STM TripModifications

Detours whose cancelled range is shorter than the detour itself

Feed timestamp 1788730587 (2026-09-06 17:36 America/Montreal) · 125 entities examined · 8 repaired

Route 165: a replacement stop is not on the detour

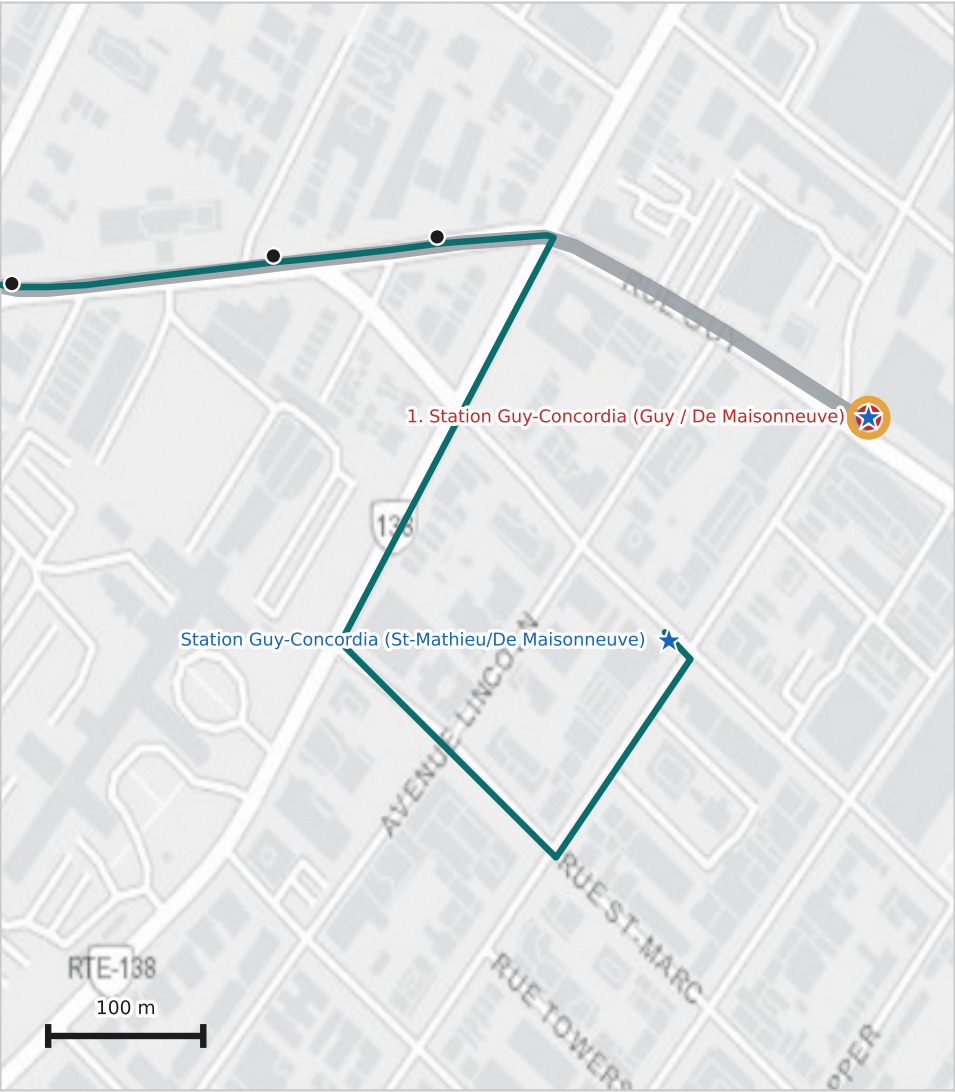
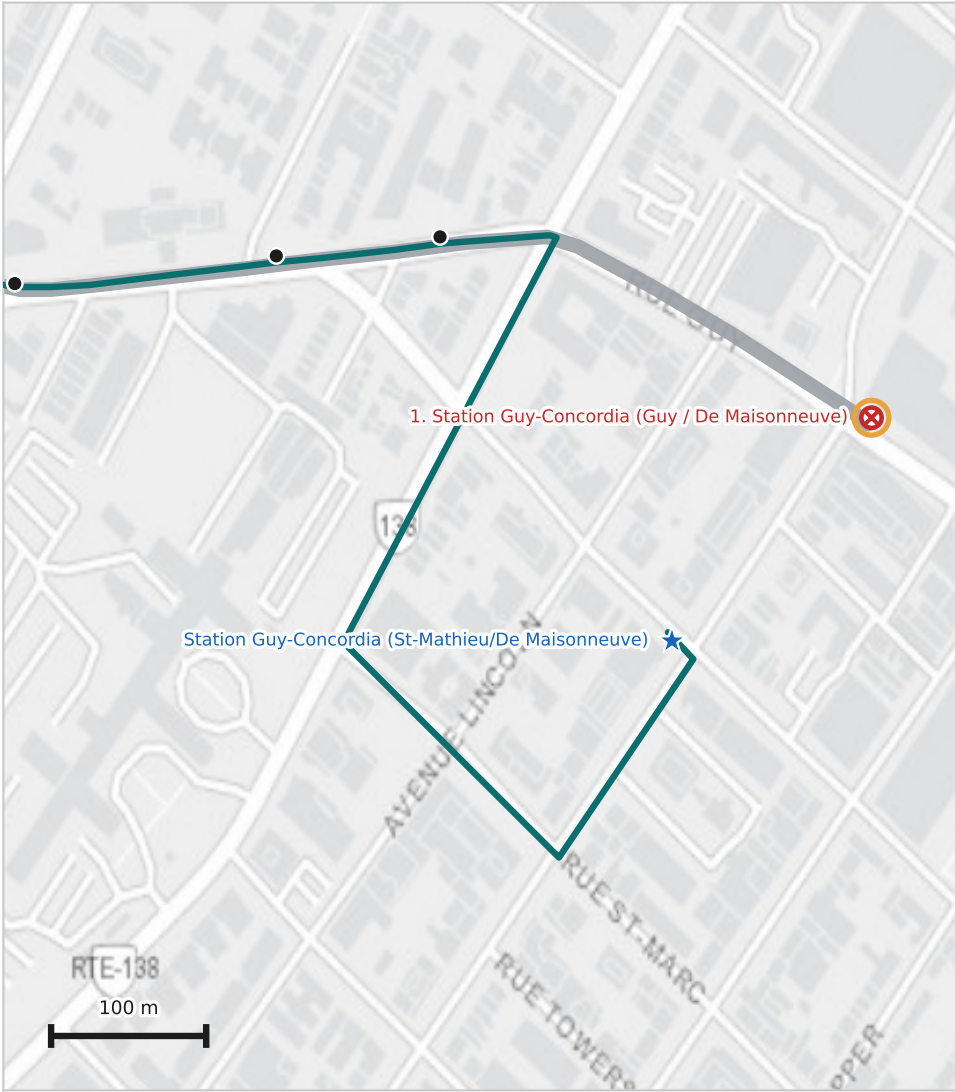
replacement stop 52201 is 173 m from it.

Route 370: a replacement stop is not on the detour

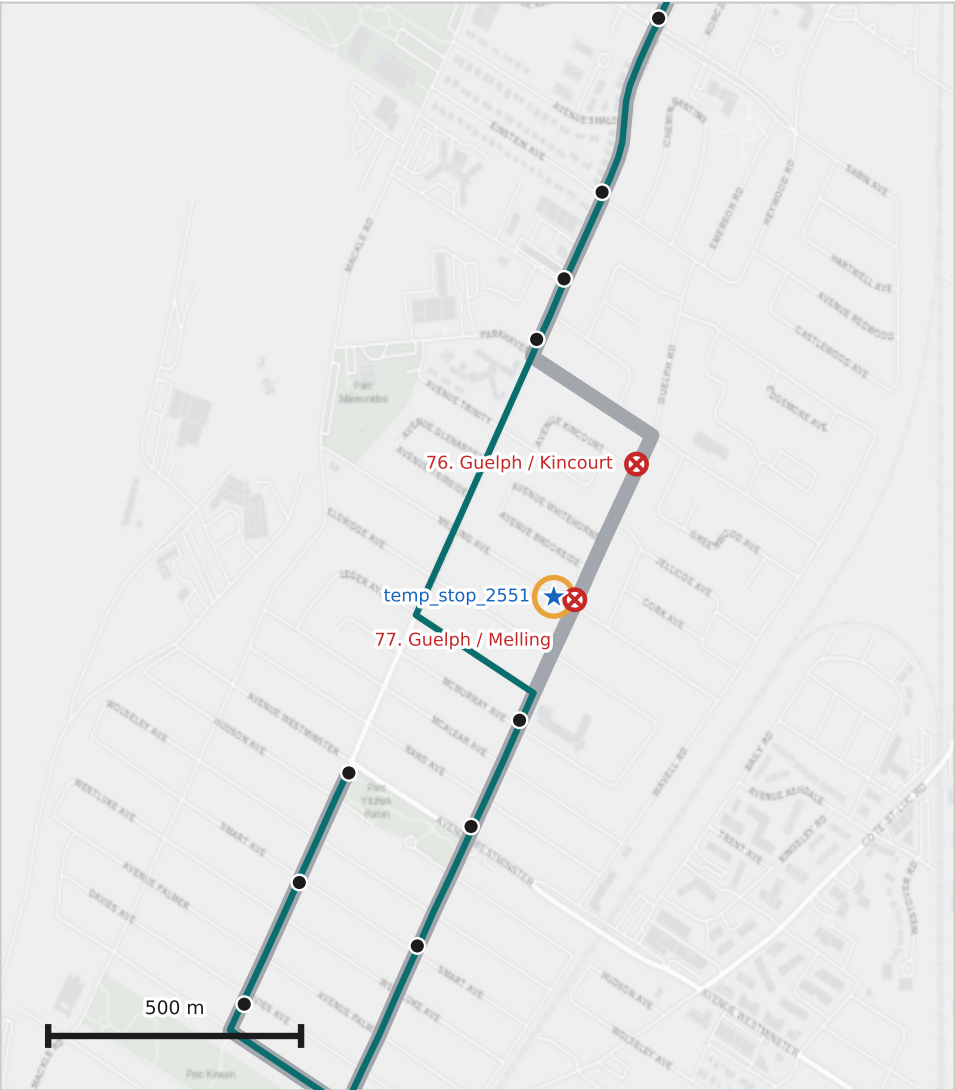
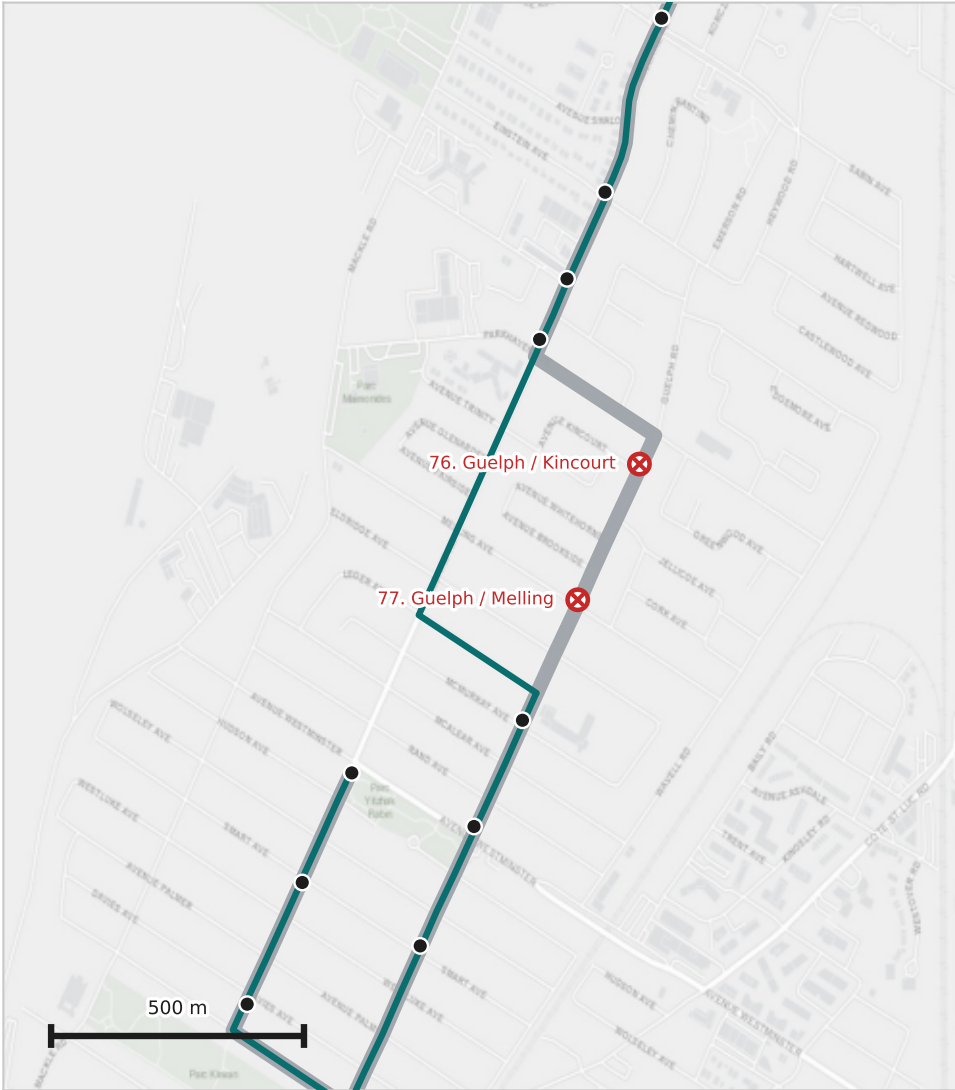
replacement stop temp_stop_2551 is 159 m from it.

Route 50: a replacement stop is not on the detour

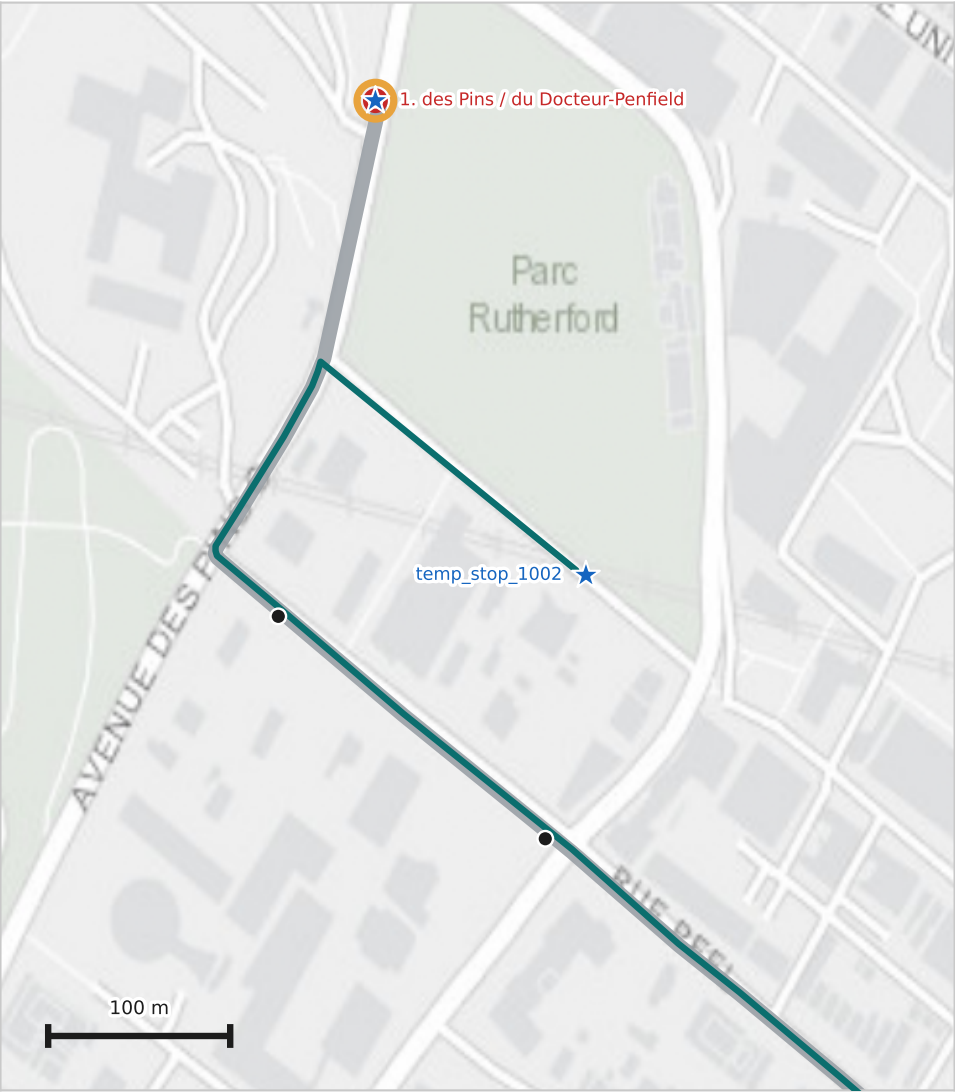
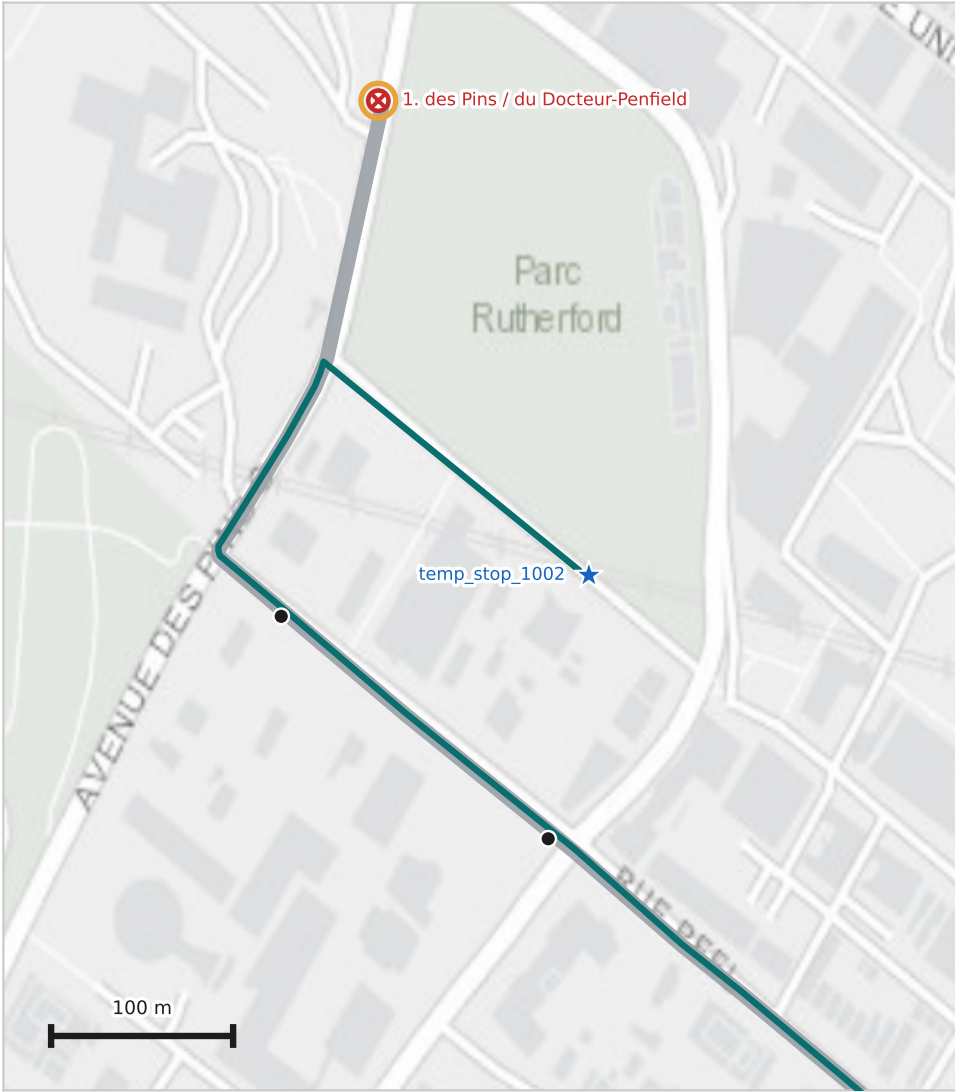
replacement stop 54346 is 123 m from it.
